SITE PLAN REVIEW AND APPEARANCE BOARD

CITY OF DELRAY BEACH

---STAFF REPORT---

ITEM: **50 SE 4th Avenue (2017-112)** - Class V Site Plan, Landscape Plan with waiver request, and Architectural Elevations to demolish an existing one-story office building and construct a 3,396 sq. ft. two-story building with restaurant uses in the first story and open air rooftop dining.

EAST ELEVATION

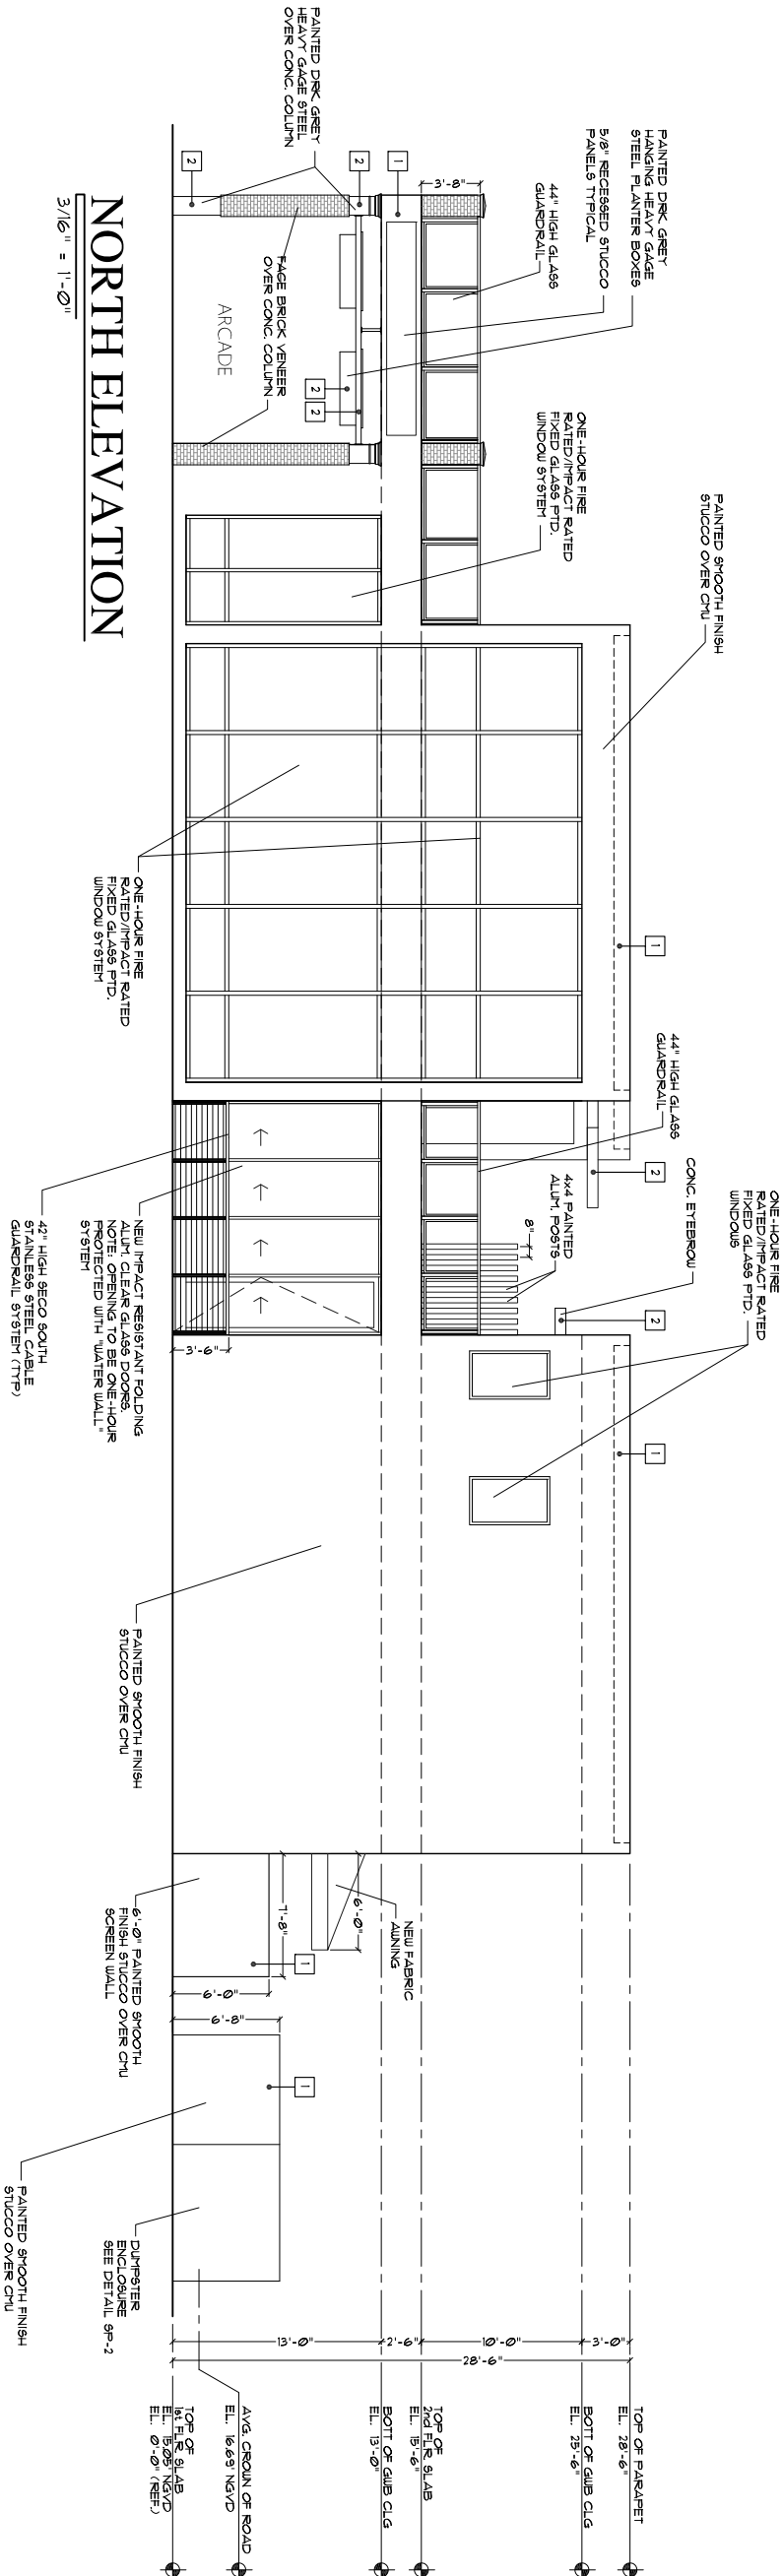
The arcade columns propose a capital that is traditional in its detailing, yet the brick veneer of the column is not consistent with grey painted steel proposed at the top and the bottom of the columns. No column base is proposed. This detailing is inconsistent with the traditional detailing common to the style; the brick material appears to be missing. **Staff recommends detailing the arcade columns with a traditional base consistent with the proposed capital and the brick veneer be applied to the whole column; this is attached as a condition of approval.**

1. The arcade columns will have a traditional base and capital, with the brick veneer applied to the full column shaft; and
2. The West Elevation will incorporate windows on the doors or wall to ensure restaurant staff can view the rear area prior to exiting the building.

WEST ELEVATION

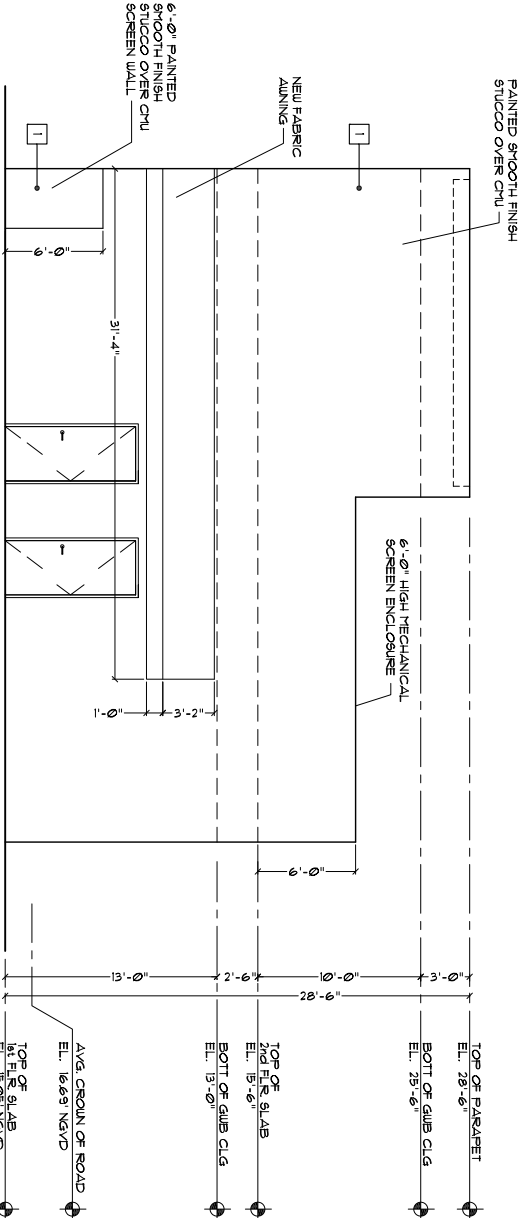
1. The West Elevation will incorporate windows on the doors and on the stairwell wall to ensure restaurant staff can view the rear area prior to exiting the building and overall improve the facade.

The West Elevation faces the rear, with parking, the car wash and refuse area. Currently, no windows are proposed, which would allow restaurant workers to survey the area prior to opening the door. **Staff recommends specifying doors that have windows or adding a window to the rear elevation to provide oversight of the rear area; this is attached as a condition of approval.**

SHEET NO.
L-1
2
DRAWING FILE NO.

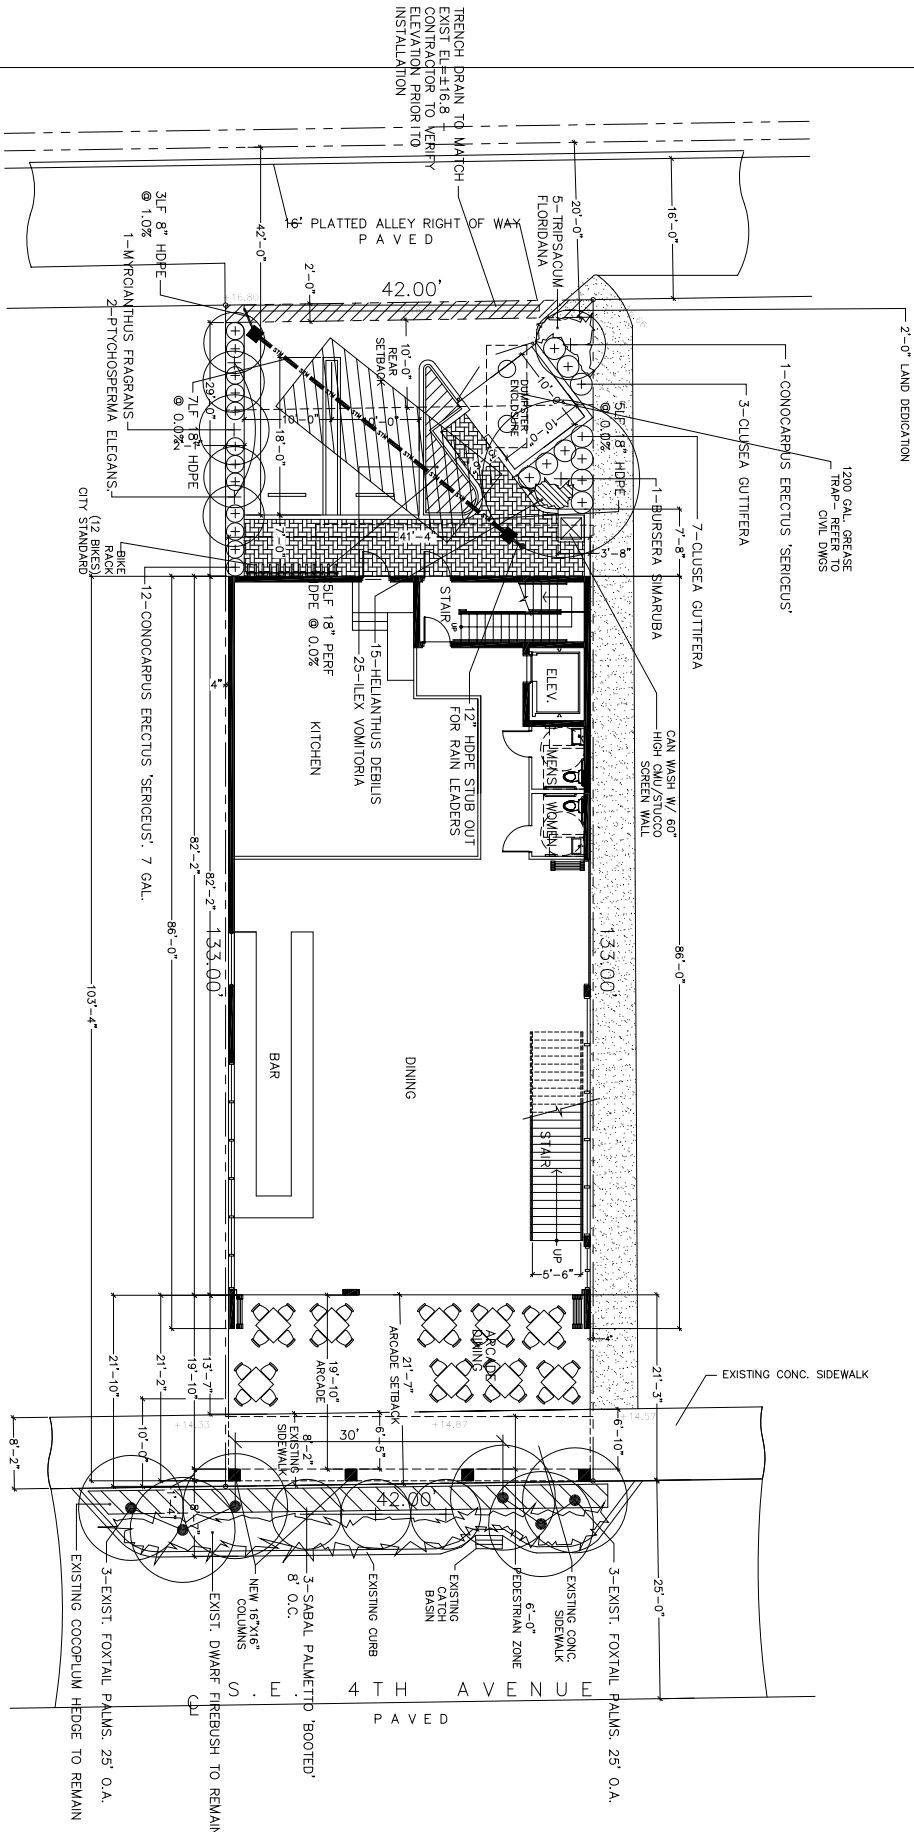
The waiver request is to LDR Section 4.6.16(H)(3)(d), which requires a landscape barrier of at least five feet between vehicular use area and the abutting property line. A barrier of 2'-1" is proposed. The area is proposed to be planted with Silver Buttonwood, 16-ft. tall Alexander Palms, and a Simpson Stopper.

1. The location and number of bicycle racks illustrated on Sheet L-1 is updated to be consistent with the Site Plan;
2. The tabular data on the Photometric Plan is updated to reflect the number of fixtures and lighting levels shown on the Proposed Lighting Plan; and
3. The word “obscure” is replaced with the word “block” on SP1.

PROPOSED SITE PLAN

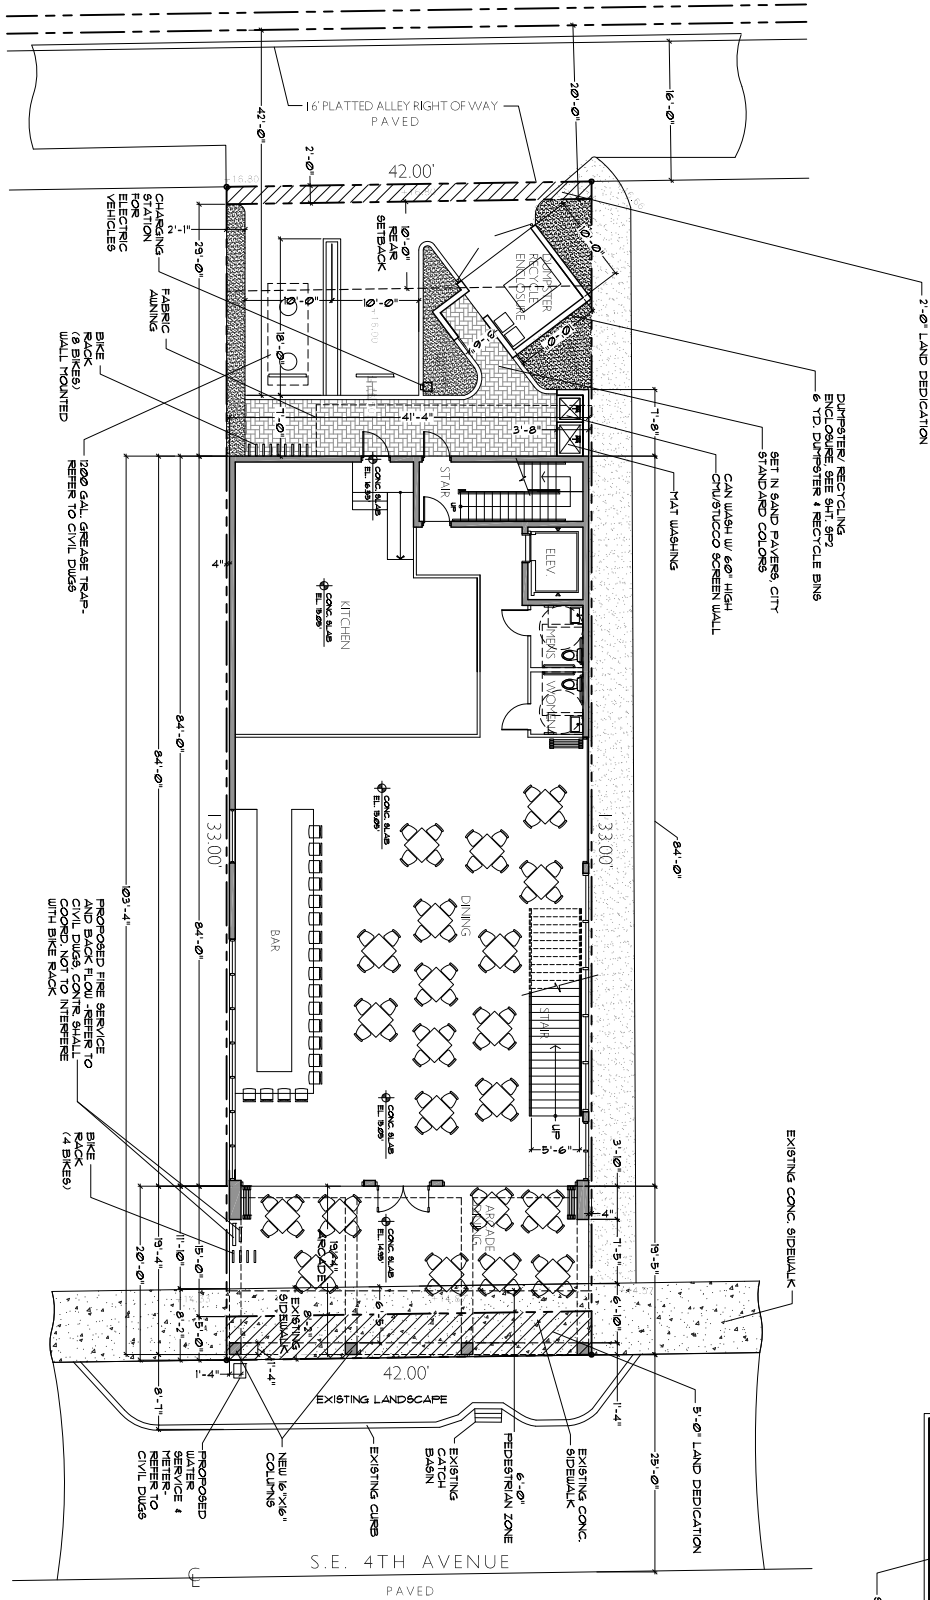
The dimensional data on Sheet SP1 requires updates prior to site plan certification. The Site Data chart has a "Total Site Area" figure that does not reflect the SE 4th Avenue right-of-way dedication, which will result in a site area of 5,376 sq. ft. Initially, two on-site and 33 off-site parking spaces were anticipated; however, only 32 off-site spaces were finalized. The Building Data and Parking charts should reduce the restaurant area from 5,886 sq. ft. to 5,742 sq. ft., consistent with the parking required and provided. 34 parking spaces. **The reduction of restaurant area from 5,886 sq. ft. to 5,742 sq. ft. must be**

illustrated on the site plan and tabular data to be consistent with the parking provided. Staff has attached this change as a condition of approval prior to certification.
